QUEENSTOWN LAKES DISTRICT COUNCIL

REPORT ON AN APPLICATION FOR RESOURCE CONSENT FOR A QUALIFYING DEVELOPMENT UNDER SECTION 25 OF THE HOUSING ACCORDS AND SPECIAL HOUSING AREAS ACT 2013 (HASHAA)

Applicant:	Queenstown Housing Limited
Application Reference:	SH190488
Application:	Application under section 25 of *the Housing Accords and Special Housing Areas Act 2013* (HASHAA) to undertake a staged subdivision to create 526 residential lots, 14 multi-unit lots, one lot for commercial purposes, lots to vest as road and reserve, with associated earthworks, access and roading, services, and landscaping; Application under s25 of HASHAA for land use consent to establish residential units within each residential lot and to establish commercial activities. Application under section 221 of the Resource Management Act 1991 (RMA) to cancel Consent Notice 7919701.16.
Location:	436 Kingston Road, Jacks Point
Legal Description:	Lot 1-2 Deposited Plan 475609 held in Record of Title 655559
Zoning:	**ODP:** Resort (Jacks Point) **PDP:** Jacks Point
Activity Status:	**Non-complying**
Decision Date:	**21 September 2020**

Figure 3: proposed flood mitigation works

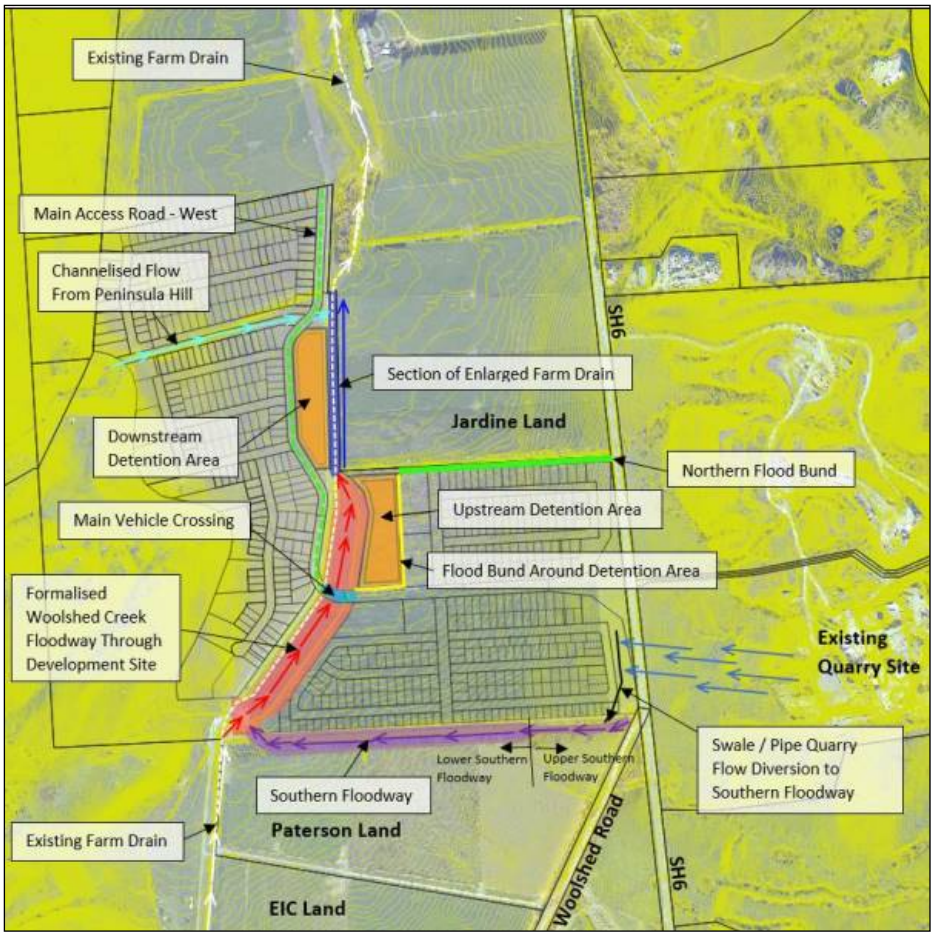
The location of these mitigation works are shown in Figure 3 below (noting upstream detention area has now halved in size):

The proposed works have been comprehensively reviewed and summarised by Mr Hopkins within the engineering report contained within **Appendix 5**. This assessment is considered accurate and is adopted for the purpose of this report, as are the recommended conditions.

Figure 3: Original application (left) and amended layout (right).

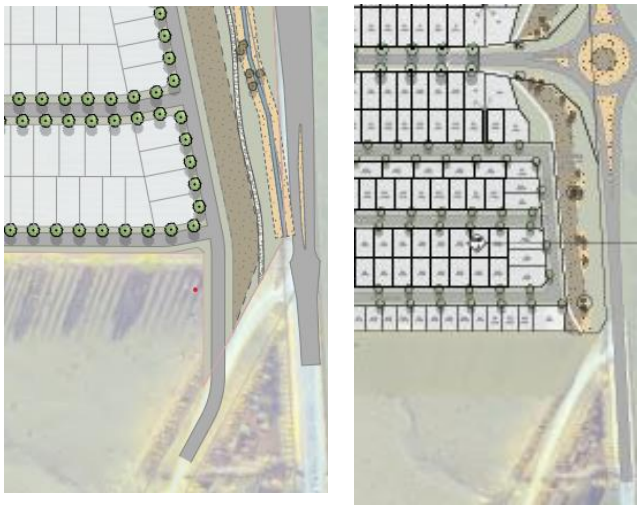
The amended design removes a road link to Woolshed Road, in the south-eastern corner of the site, that was part of the original application. A walkway/cycleway connection is proposed. While it understood that Woolshed Road's link to the State Highway may be removed, a roading link from the SHA into Woolshed Road provides additional connectivity and potentially the only access south, should the balance lot (Lot 915) not be developed. Figure 3 shows the amended design versus the submitted design.

A street connection to Woolshed Road should be provided. It is acknowledged that this may require adjustment to the roading layout of the south-eastern quadrant of the site.

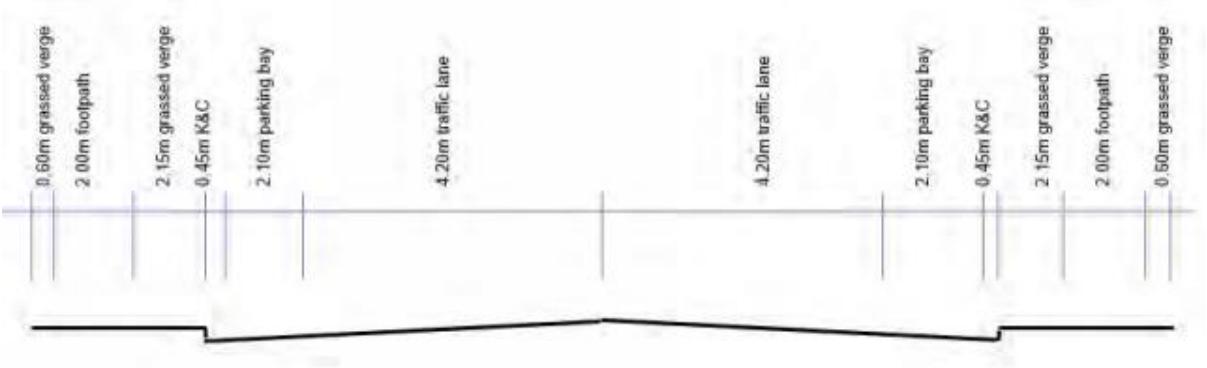
East (Chain 0-500m)
The applicant has proposed the initial eastern third (500m) of Road 1 from the SH6 boundary to the culvert crossing of Woolshed Creek and as contained within Lot 1002 and a portion of Lot 1010, will have a 21 m legal width, a movement lane of 8.4 m, 2.1m indented parking bays, 2.0m footpaths, and a target operating speed of 50 km/hr. I am satisfied that this design meets or exceeds the Council standard for an E13 (collector) road.

The applicant proposes a reduced 500mm grass berm between footpath and lot boundary. This reduced berm has previously been agreed as acceptable to Council as part of the neighbouring Hanley Farm development and is suitable to accommodate any required service boxes or plinths.

I am satisfied that initial eastern third (500m) of proposed Road 1 has been conceptually designed in accordance with the QLDC COP and has been confirmed appropriate for use by Council's consulting traffic engineers. To ensure this portion of road is constructed in accordance with QLDC standards, I recommend a consent condition that the eastern 500m of Road 1 from the SH6 boundary to the Woolshed Creek culvert shall be designed and formed in accordance with the QLDC COP, Table 3.2 "Suburban, Live and Play, Primary Access to housing up to 800 du", Figure E13 with the following specific requirements:

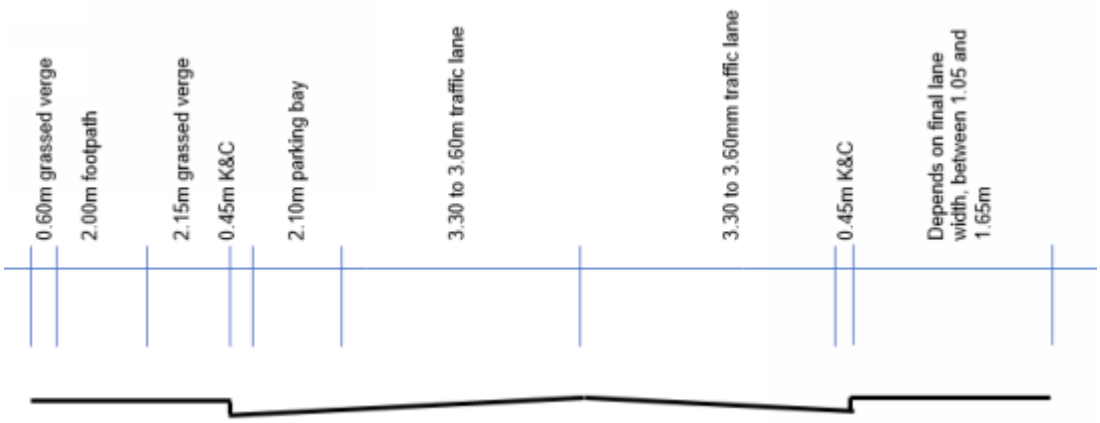
North (Chain 500-1430m)
The remaining northern two thirds (930m) of Road 1 from culvert crossing of Woolshed Creek north and as contained within Lot 1014, 1011, and a portion of Lot 1010, will have a reduced 16 m legal width, a movement lane of 8.4 m, and a target operating speed of 50 km/hr. The proposed design does not meet the required E13 standard due to the reduced legal width. The applicant has justified this non-compliance in legal width due to the lack of footpath or on street parking requirement on the eastern side of this road. The eastern side of this portion of Road 1 directly fronts a drainage reserve and therefore does not specifically require on-street parking or a footpath.

I have reviewed the proposed design of this portion of road and agree that due to the drainage reserve (Lot 804) on the eastern side, continuous indented parking (2.1m) and a footpath (2m) is not required on this side of the road. Noting that an off-road path is proposed within Lot 804 which will reduce the need for an on-road path. The removal of these aspects of the design will reduce the required legal width by 4.1m and therefore I am satisfied that the proposed 16m legal width is suitable for use.

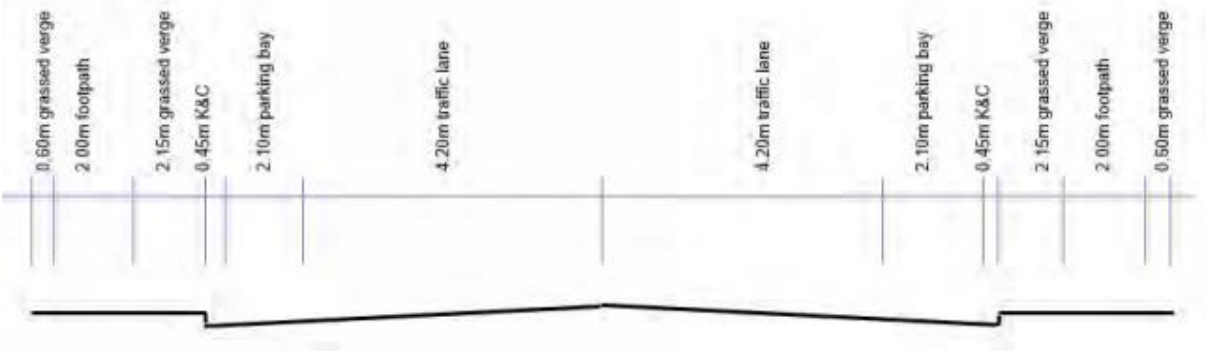
The applicant proposes Road 2 (north and south) as contained within Lot 1003 and 1007 will have a 21 m legal width, a movement lane of 8.4 m, 2.1m indented parking bays, 2.0m footpaths, and a target operating speed of 50 km/hr. I am satisfied that this design meets or exceeds the Council standard for an E13 (collector) road.

The conceptual design of this this road has been peer reviewed by Novo Group (as Council consulting traffic engineers) and has been confirmed appropriate for use, taking into account its future public transport function under the NOF and the likely future increased traffic demand from Hanley Farm and the undeveloped land to the north and south. This confirmation is as per the Novo Group

I am satisfied that Road 2 has been conceptually designed in accordance with the QLDC COP and has been confirmed appropriate for use by Council's consulting traffic engineers. To ensure this road is constructed in accordance with QLDC standards, I recommend a consent condition that the Road 2 shall be designed and formed in accordance with the QLDC COP, Table 3.2 "Suburban, Live and Play, Primary Access to housing up to 800 du", Figure E13 with the following specific requirements:

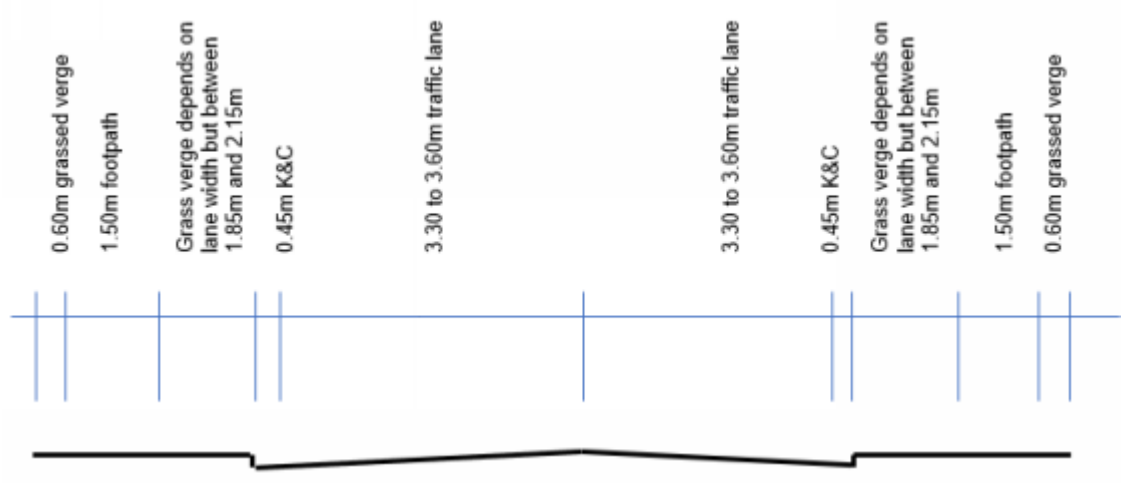
For the majority of these roads the applicant has proposed a 16 m legal width, a movement lane of 6.6-7.2 m, 1.5 m footpath on both sides, and a target operating speed of 40 km/hr.

While I am generally satisfied that the proposed design complies, I am not satisfied that a movement lane below 7.2m will be sufficient. The number of dwellings serviced by these roads is less than 100 and therefore road typology E12 under the QLDC CoP allows for parking within the movement lane. The CoP (Section 3.3.2.4) requires all carriageways less than 7.2m to include broken yellow no-parking on one side. The applicant does not propose to provide separate recessed car parks. Car parking will instead be provided within the movement lane. At 7.2m on-street parking is possible on both sides of the road while maintaining a 3m live movement lane. At 6.6m the live movement lane would be reduced to 2.4m which is deemed an insufficient width to maintain safe through traffic. I therefore recommend that as a minimum these roads shall be designed with a 7.2m carriageway excluding the K&C width.

Overall, I am satisfied that proposed Roads 3, 4, 5, 6, 7, 8, 9, 10, 11, 12 have been conceptually designed in accordance with the QLDC COP. To ensure these roads are constructed in accordance with QLDC standards, I recommend a consent condition that Roads 3, 4, 5, 6, 7, 8, 9, 10, 11, 12 shall be designed and formed in accordance with the QLDC COP, Table 3.2 "Suburban, Live and Play, Primary Access to housing up to 200 du", Figure E12 with the following specific requirements or exceptions:

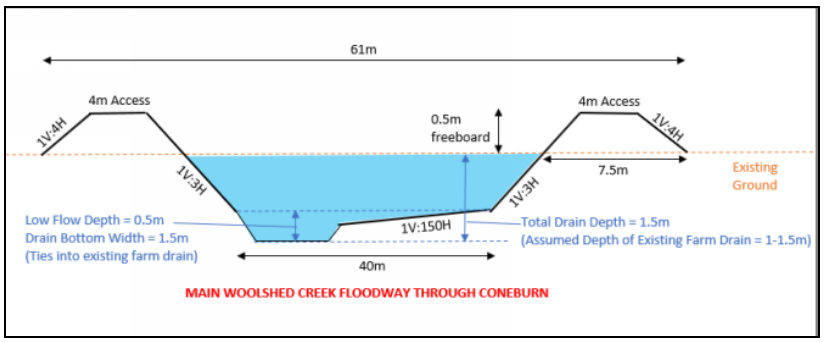
along the banks would provide 0.5m freeboard above the 100yr ARI event to allow for residential development. The shape of the existing farm drain will be incorporated into the floodway design as a means to provide a low flow conveyance pathway for smaller storm events.

I am satisfied that the 100 yr design flood event flow, with provision for climate change, has been calculated by a suitably qualified engineer (Fluent Solutions) and this flow has been used to design the concept flood conveyance channel with velocity limiting drop structures. I am satisfied that the exact design and conveyance of this channel will be confirmed and approved under detailed design approval and if required a peer review of the design obtained. I therefore recommend a consent condition that prior to the commencement of works the consent holder shall provide for approval detailed design plans for upgrading of the Woolshed Creek Floodway through the development in accordance with the Fluent Solutions report titled *Coneburn Flood Management – Full Site Flood Mitigation Assessment'* ref Rp-20-01-31-Aop-Q000511 Rev1, dated 3rd February 2020. The upgraded channel shall have a minimum capacity suitable to convey the 100yr ARI event with provision for the minimum freeboard as required under the Section 4 of the QLDC Code of Practice. This design shall also if required include suitable measures (armouring, drop structures etc) to ensure that velocities are controlled, and associated risk of scour damage to the development and downstream properties addressed. If required by Council a peer review of this design and supporting calculations will be undertaken at the consent holder's cost.

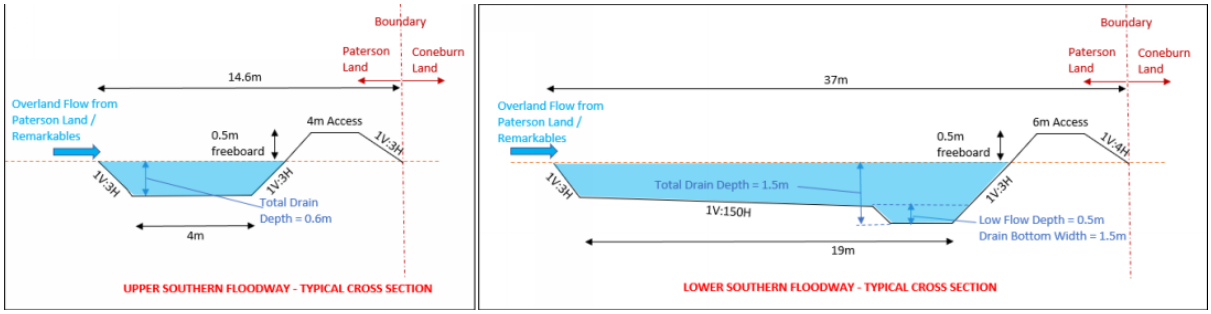
The southern floodway is currently an informal farm drain that directs flows from two ephemeral creeks to the south-east to Woolshed Creek. Fluent Solutions propose to upgrade this drain to a formalised floodway that will be sized to convey the 100 year event. This formalised channel will include the construction of a bund between the channel and the residential lots to provide the required 0.5m of freeboard to the residential lots. Currently this farm drain runs two thirds of the length of the southern boundary of the development. As part of the floodway upgrade the channel and associated bunds will be extended east to SH6 via the 'upper southern floodway' channel. A concept design section for the upper and lower southern floodway is as detailed within the Fluent Solutions report and shown below.

I am satisfied that the fluent concept design and reporting confirms that the proposed southern floodway and associated bunding will ensure that the development will be protected from the flooding and alluvial fan hazards to the south-east. To ensure that this floodway and bunding is appropriately design and constructed, I recommend a consent condition that prior to the commencement of works the consent holder shall provide for review and acceptance detailed design plans for the provision of the southern floodway to convey a minimum 100 yr rainfall event (with provision for climate change) and bunds to provide the minimum 0.5m of freeboard to the residential lots. The floodway and bunds shall be design in general accordance with the Fluent report titled *'Coneburn Flood Management – Full Site Flood Mitigation Assessment'* ref Rp-20-01-31-Aop-Q000511 Rev1, dated 3rd February 2020. If required by Council a peer review of this design and supporting calculations shall be undertaken at the consent holder's cost.

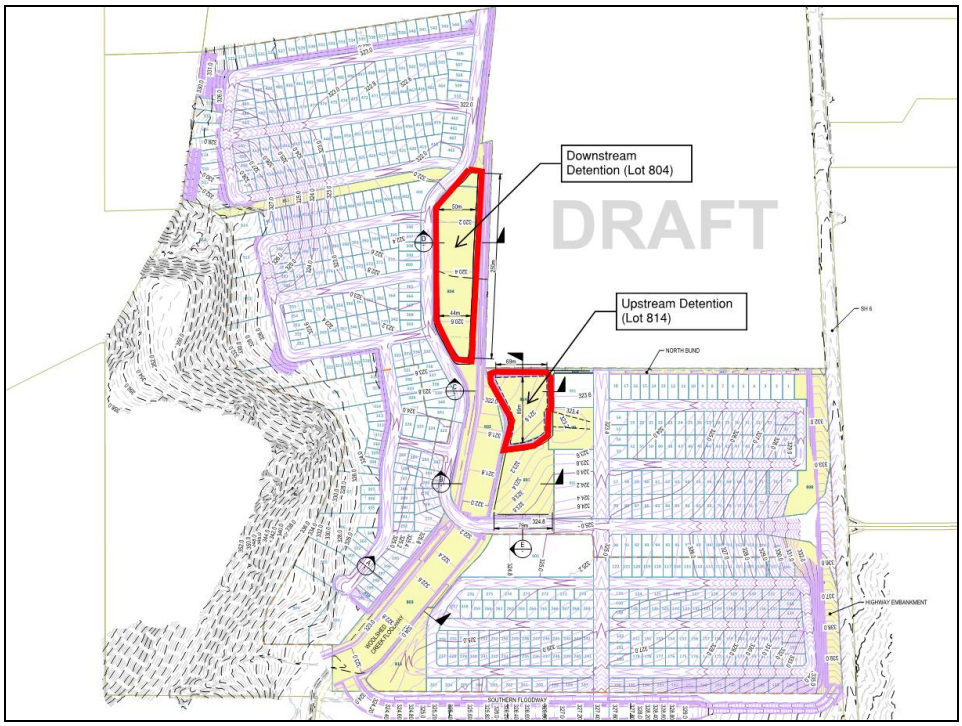
The proposed ponding areas are to be locate within local purpose drainage reserve Lots 814 and 804. The location of the proposed detention areas are show in red below-

The two detention ponds are positioned near the middle of the site where flow from the formalised Woolshed Creek Floodway becomes constricted at the connection point to the enlarged farm drain. Here, flood flows will spill out into the two detention ponds and existing flood plain on the neighbouring to the north-east (the Jardine Land). The detention ponding areas will be designed to fill using spill weirs to allow inflow from the flooded area during the peak of the storm and ensure that flooding on neighbouring and downstream land is no greater than pre-development levels.

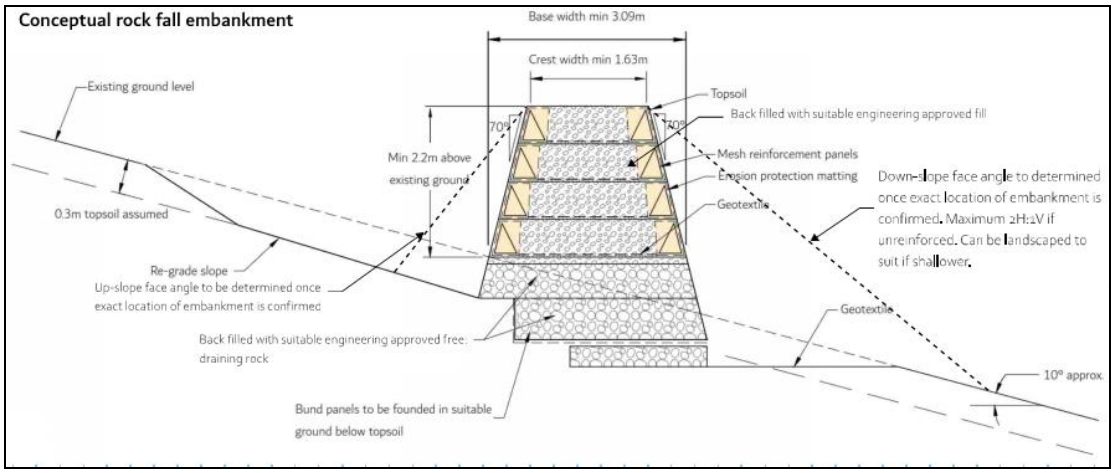
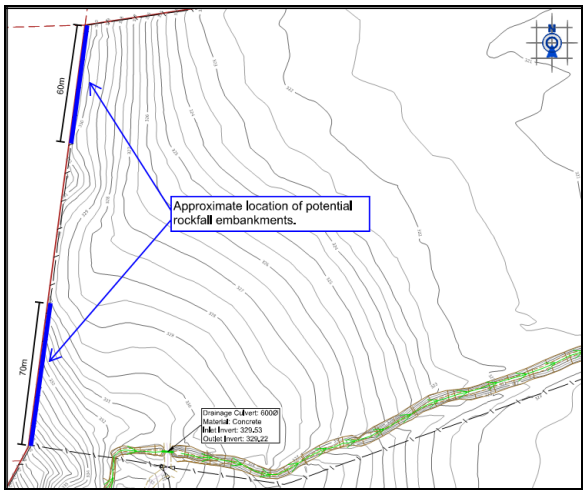
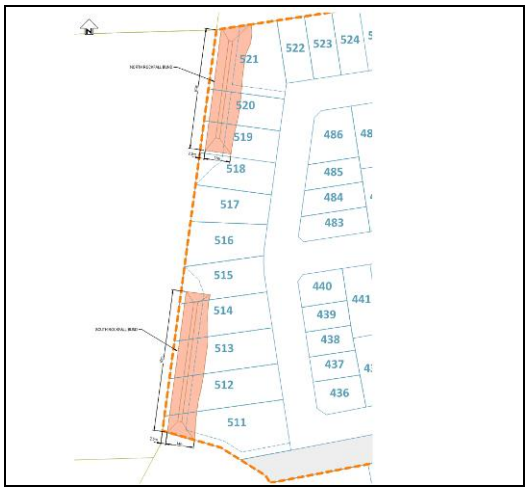
Based on these conclusions Geosolve have produced a concept design for a reinforced rockfall catch bund in two discrete location on the north-west boundary of the development. One bund will be located within Lots 511-515 and the other within Lot 518-521. The minimum dimensions of this bund have been determined using the specific findings of the RAMMS modelling. The bund concept is as per the below cross-section.

Overall, I accept the Geosolve assessment and modelling provided, and I likewise accept the concept designs for 2x mitigation rock fall catch bunds. To ensure that these bunds are appropriately designed and constructed, I recommend a consent condition that prior to the commencement of work the consent holder shall provide for review and acceptance detailed design plans for the provision of two rock fall protection catch bunds generally within Lots 511-515 and Lots 519-521. These bunds shall be designed to address the risk identified within Section 6 of the Geosolve report titled '*Geotechnical*

Figure 1: Site Access Visibility Example

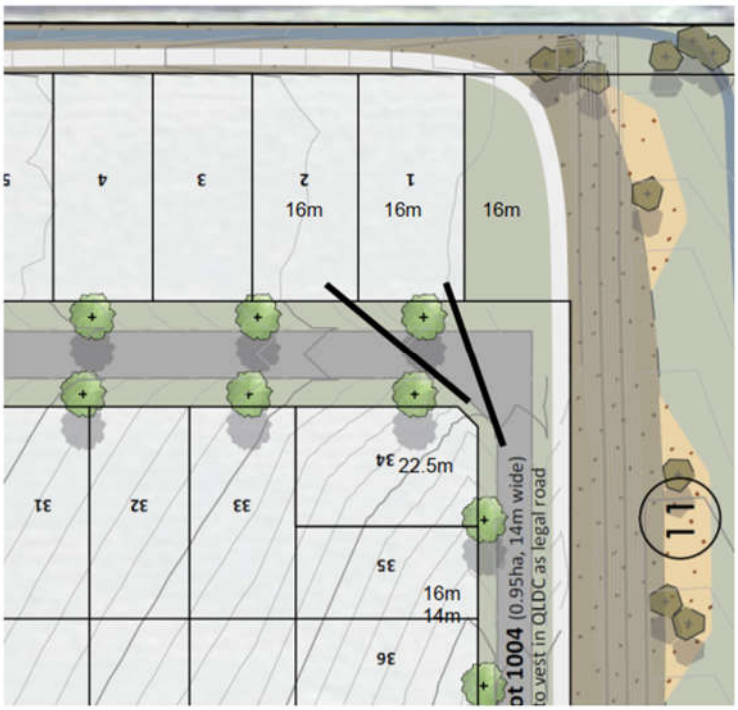
20. There will be sight line non-compliances out of some of the residential Lots where they are located near bends in the road (such as Lots 2 to 5 and Lots 34 to 37). The assessment provided in respect of this non-compliance indicates that a visibility splay of 27m is sufficient to cater for a 30km/hr speed environment. The example provided in the RFI response is included as **Figure 1**. The commentary provided with this is as follows:

close to its boundary with Lot 33. Given the desired target operating speed of 40km/h we believe 30km/h is an acceptable figure to use in relation to curves of this type.
